HISTORIC LANDMARK COMMISSION STAFF REPORT

1120 E 400 S Major Alterations PLNHLC2014-00884 University Historic District 1120 E 400 South January 15, 2014

This is a request by Andrew Nielson for major alterations to the property located at approximately 1120 E. 400 South, in the University Historic District, and within the R-2 (Single and Two Family Residential) zoning district.

a. Alterations to basement windows and window wells.

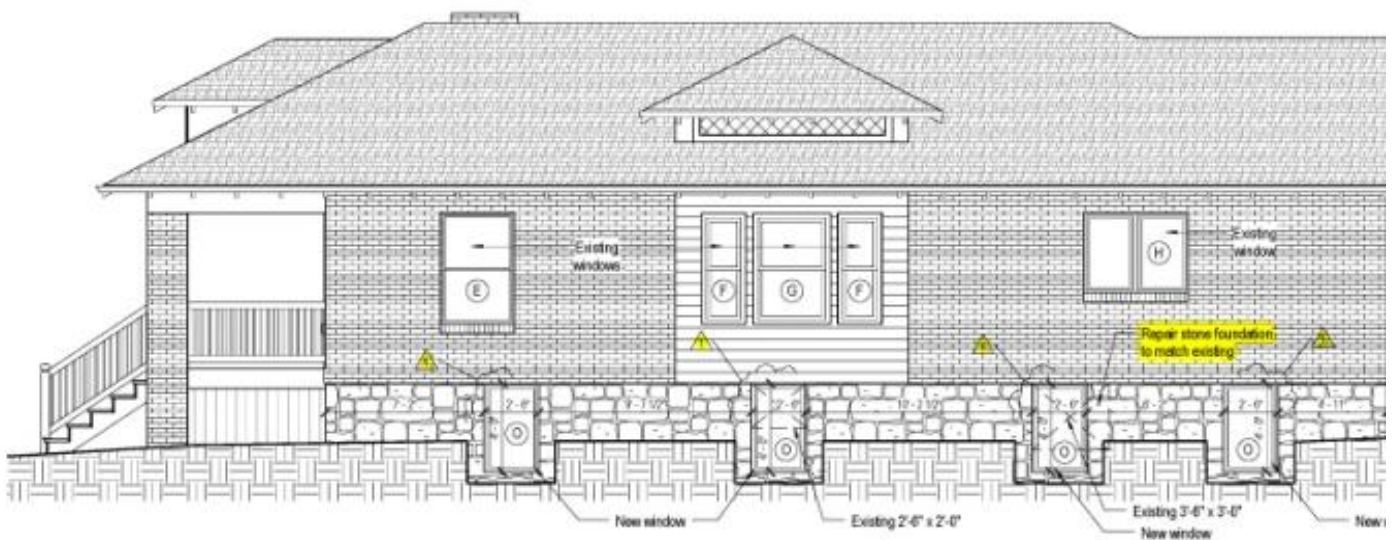
The applicant proposes to make changes to the basement windows that were not installed in accordance with the original COA. The original COA approval was for four new vinyl casement basement windows all measuring 2'6" x 4'0". There were two existing basement windows at the time: one window measured 2'6" by 2'0" and the other measured 3'6" x 3'0". Instead of installing the 4 vinyl casement windows, 3 vinyl sliding basement windows were installed. All the new windows installed measure 4'0" x 4'0". The applicant proposes to keep the same sliding windows instead of the casement windows and proposes to recess these new basement windows by 3.5". The applicant is also proposing to fill in the gaps between the new windows and the sandstone foundation with smooth hardie board trim. The original COA required the applicant to repair the stonework around the windows to match the other existing window. The window wells measure 61" x 39" x 38" (north), 56.75" x 39" x 38" (middle), 61.5" x 39" x 38" (south) and all are made with 2x12s Redwood lined with tar paper.

The proposed vinyl material for the windows is generally appropriate since that portion of the home is not readily visible from the street with the west fence in place. Though the west fence has since been removed, the applicant has proposed a new 6' cedar fence as a replacement. With a fence in place the proposed basement windows will not be readily visible from the street. The manner in which the basement windows were installed is not appropriate since they are flush with the exterior and should be recessed. The applicant proposes to recess the basement windows 3.5" to provide a similar profile and look as the historic windows on the property.

- The basement windows:
 - Replace with casement windows,
 - Resulting gaps from the crumbling sandstone between the windows and the original sandstone be repaired and filled in with high quality matching sandstone that is compatible

- Recess the windows to match the profiles of the existing historic windows
- Window Wells
 - Size of window wells correspond to egress standards and the type of windows approved

New kitchen window and covered window on west elevation

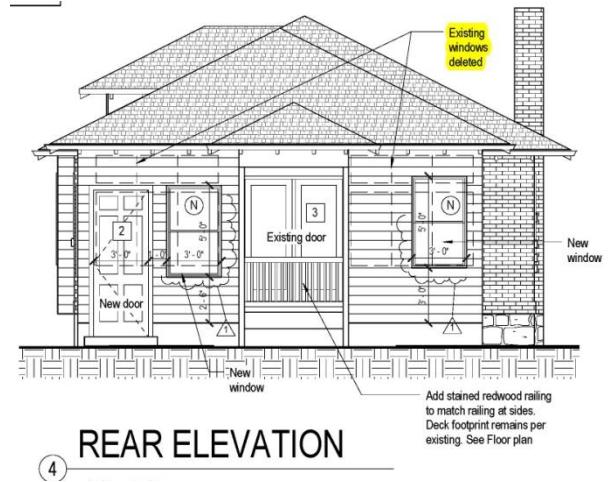
Although a double hung window would be appropriate, the proposed double-hung wood windows to replace the previously existing garden box window are not appropriate since the historic window opening was not retained. The wood material is appropriate as all the historic windows on the home are wood. However, the historic window opening can still be seen today and the proposed window is smaller than the original window opening.

- Kitchen Replacement Window
 - New double hung windows should match all the other windows on the home in material, dimension and design
 - New window should fit the entire original window opening and be designed similarly to original windows on the building

New rear addition design and new deck

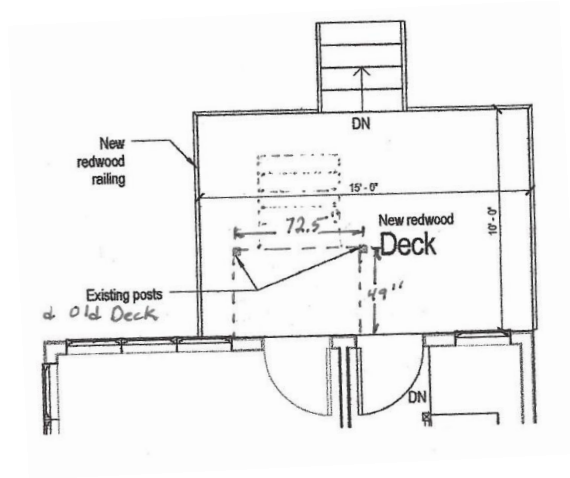
The applicant is requesting approval to legalize the removal of the former deck that measured approximately 6' by 4' and the building of a larger deck with stairs located at the center of the deck leading towards the rear of the property. The requested deck measures 10' by 15' and is made of redwood. The balusters are 37" tall and are spaced 3.75". The top railing on the deck is constructed of 2x4s and the design of the new deck railing is a simple stick design in which the stick balusters are nailed to the exterior of the top railing and then nailed to the base of the deck. The handrails for the stairs contain a top hand rail and no balusters.

The alterations to the rear addition and deck do not meet this standard. The asymmetry of the rear addition and deck are not compatible with the historic character of the property. The placement of two doors directly next to each other on the rear addition is not characteristic of single family bungalows in the neighborhood. The remnant awning and posts from the old porch along with the two doors create a confusing and asymmetrical design that does not retain the character of the home. The deck stairs further add to this discord as the stairs do not line up with any elements of the rear addition design. The simple stick design of the deck railings and balustrades does not retain the historic character of the home.

- Rear Addition Alterations and New Deck:
 - A comprehensive redesign which results in one back door, logical reconfiguration of the awning, windows, and placement of deck stairs, and that the railing and balustrade design be more compatible with the size, scale, and character of the property.

3. Remove and replace fence along West edge of property

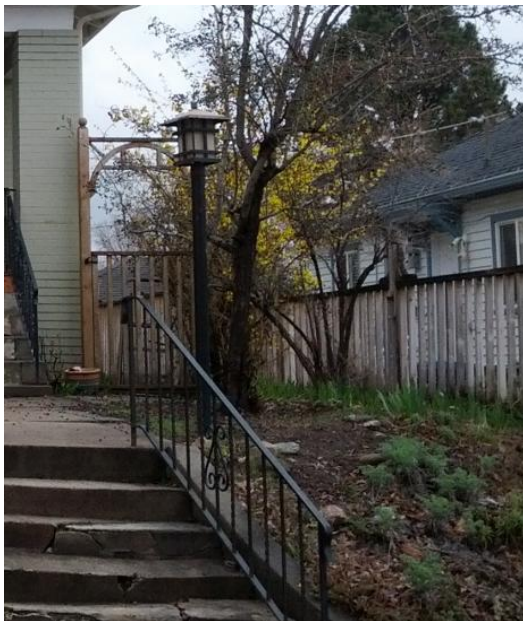
The applicant is seeking approval of the removal of the wood fence that was removed along the west side of the property. The applicant would like to replace it with a 6' cedar wood fence with 8' posts. The proposed fence will be located along the property line and extend between the front elevation of the house and the rear existing fence shared with the neighbor to the west. The applicant proposes a design that is similar to the picture below.

The existing fence that was removed was not considered an historic feature. The proposed 6' cedar wood fence along the western edge of the property will not change the historic character of the property.

4. Concrete work, changes to shape of stairway

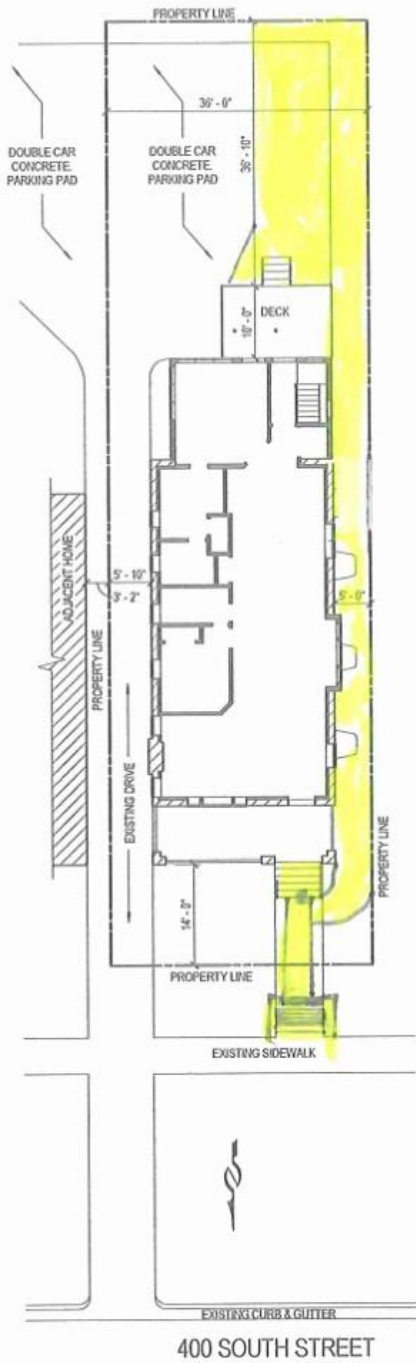
The applicant is seeking approval for concrete work that was completed on the stairs in the front yard, the porch stairs, the walkway connecting the two sets of stairs, and the walkway along the western edge of the home leading towards the back of the home. The shape of the stairway in the front yard was changed from a curved design to a straight design. The set of porch stairs was repaired with a new layer of cement and the concrete work was continued from the front walkway to the west side of the property to the back of the property.

The design of the stairs in the front yard was changed as new concrete work was completed on the property. The original set of stairs that fanned out at the base changed to a design with straighter lines. This straight design is not compatible with the majority of front stairs in the neighborhood and along the block face that have stairs that fan out at the base of the stairs. The change to a straight stair design does not retain and preserve the historic character of the property. The design of the front set of stairs was a unique feature of the property and converting this design to a design with straight lines is not appropriate.

The majority of properties on the block face and neighborhood that have front yard stairs that fan out at the base. Stairs that fan out at the base are characteristic of the neighborhood and are likely historic. The original front yard stairs at the subject property are particularly unique. These stairs ascend higher than others in the neighborhood so the fanned stairway is especially pronounced. The change from a more pronounced curved stairway to this simple and straight design changes this distinct feature of the property and is not appropriate.

The front steps did contain some cracks that needed to be repaired. The extent of repairs needed did not require replacement and redesign of the stairs. The original stairs were unique because they fanned out at the base and were a distinct feature of the property. The majority of the properties along the same block on 400 South have front stairs that fan out and this design appears to be common in the larger neighborhood. The change to the front stair design is not appropriate and it does not preserve the historic feature of the property.

- Concrete Work – front stairs:
 - Reinstate the fanned stairway design

5. Front Porch and Front Yard Handrails

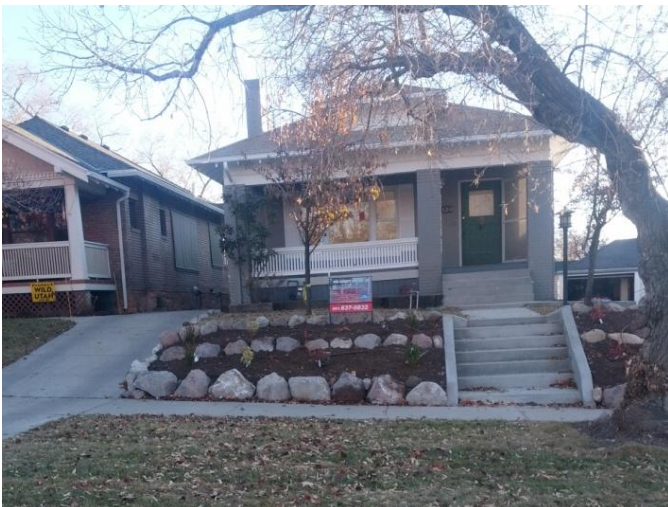
The applicant is seeking approval for the removal of the front metal railings along the west side of the stairs and proposes to replace them with similar metal railings. The proposed new metal railings mimic the design of the previously unoriginal and inappropriate metal railings. Although a stop work order is currently in place on the property, new metal railings have been installed without approval.

The front metal railing that was in place, but which has since been removed was not a historic element of the porch. Between application and the publication of this staff report, new metal handrails have been installed along the east side of the stairs on the property. Since the handrails are a new detail, they should be replaced to be compatible with the design of the original porch. The wood railing around the porch appears to be historic, and wood material would be suggested for at least the stair hand rail adjacent to the porch to best maintain the character of the home. More flexibility can be granted to the front yard handrail. The replacement railing installed is a more contemporary thin white painted metal. This material and design is not compatible with the historic character of the home. Using wood and taking inspiration from the existing wood porch balustrades and railing would make the proposed porch handrails more compatible.

The metal licorice style railing is not compatible with the original porch in terms of material and design. This metal or wrought iron was commonly used to replace porch railings in the 1950s and 1960s. Although the metal railing that was installed seeks to replace a later inappropriate choice of railing, there is no historical basis for the replacement. There can be more flexibility with the front yard handrail since there is not a lot of historical basis to determine a wood handrail was used at the front of the property.

- Front Porch and Front Yard Handrails:
 - Porch handrails should match the size, scale, material, and character of the existing historic porch
 - Front yard hand rail should be simple in design and extend from the top of the stairs to the sidewalk

Painting of Original Unpainted Sandstone Foundation

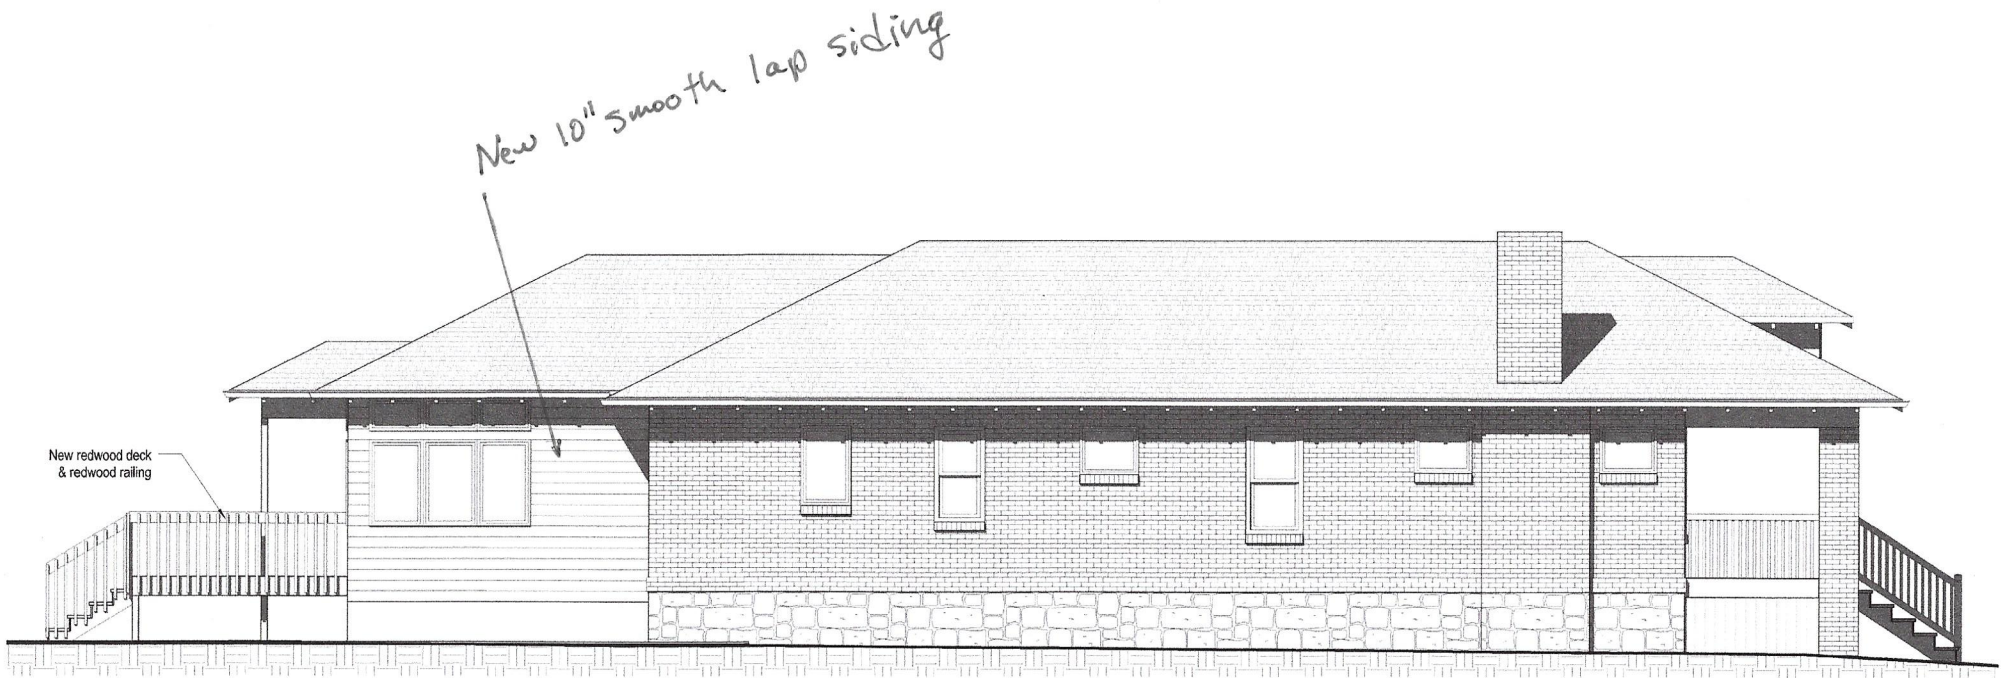
This standard is not met. Painting the original sandstone foundation is inappropriate. The original sandstone foundation is a distinct feature of the property characterizes the historic property and the paint on the sandstone should be removed in the gentlest manner to prevent potential damage. This standard can only be met if the applicant works with staff to find the gentlest means to remove the paint off the historic sandstone.

- The original sandstone foundation was painted. Do you plan to keep or remove the paint? If removing, describe the type of treatment you will be using to remove the paint. We plan to keep the paint. Some parts of the sandstone were painted with green overspray paint previous to our ownership and since it looked so bad in areas, that sandstone was painted to look much better. (see Picture 22)

- Painting of the original sandstone foundation (the applicant should work with staff to find means the gentlest means to remove the paint from the sandstone)

Finding: This standard is not applicable. This standard can be met if the applicant works with staff to find means to best remove the paint on the sandstone in the gentlest manner possible.
